Project Design

Revision A - 24th October 2022

The proposed development seeks an extension, change of use and alterations to Kilnamanagh Shopping Centre. A two storey extension is proposed along the centre's eastern elevation (Grounds floor area 1,780sgms and First Floor Area 877sgms). Change of use of the first-floor retail area (last used by Dunnes Stores as textile sales space) which will be extended and subdivided to provide for two new non-retail, service units. Unit No.1 will extend to c.1,411 sq.m for use as a Health Centre and Unit No. 2 will extend to 790sqms for use as a gym. Removal of condition 3 of PA Ref: SD06a/0095 to allow for the increased net sales area. This will allow for the increase in net comparison sales space at ground floor level. New entrance ramp and steps at the north of the extension. The southern lobby entrance into Dunnes Stores will be demolished and replaced with a new glazed lobby entrance measuring. New walkway canopy generally on the north and south elevations. New ramped access next to existing pedestrian entrance steps on Mayberry Road. Reconfigure existing entrance to Treepark Road including revised parking layout generally around the east s

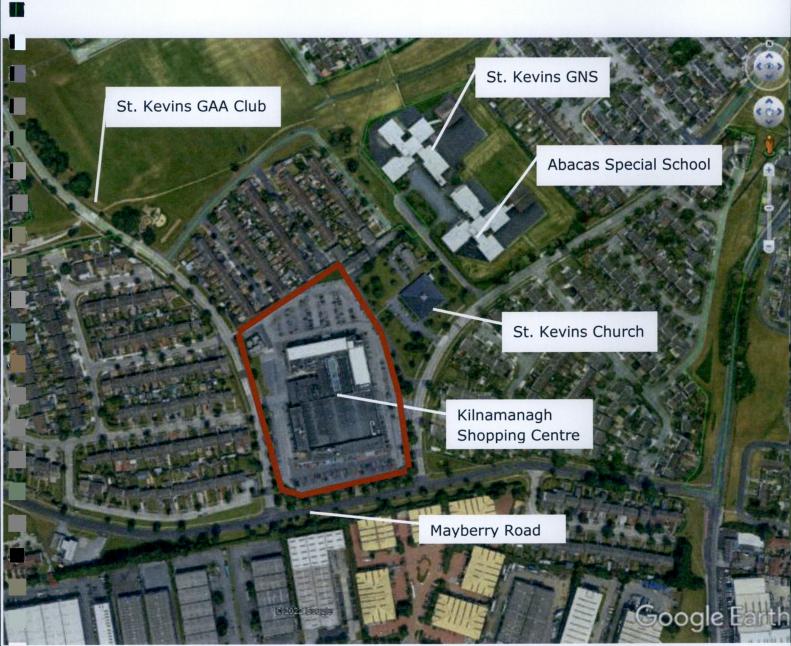
It is noted in the RFI that the signage on the building should be reduced – the proposed signage is in keeping with current Dunnes Stores standard signage throughout the country and we would contend that the current signage is to be replaced to be more in keeping the new proposed signage. The building is set back from the roadside by 30m and therefore corporate signage is important to enhance the proposed new look of the centre in the round. Please see images throughout the country for reference and additionally the next images showing corporate logo and its sizes.

Removal of Totem signage – it is our contention that a totem sign to the entrance and on the street frontage is required as a standard form of advertisement to the centre and provides a sense of place to the community – these proposed totem signs are modest is size and do not raise any contention or observation from the public in this area. We would request that these are approved as part of the overall revitalisation of the centre and environs.
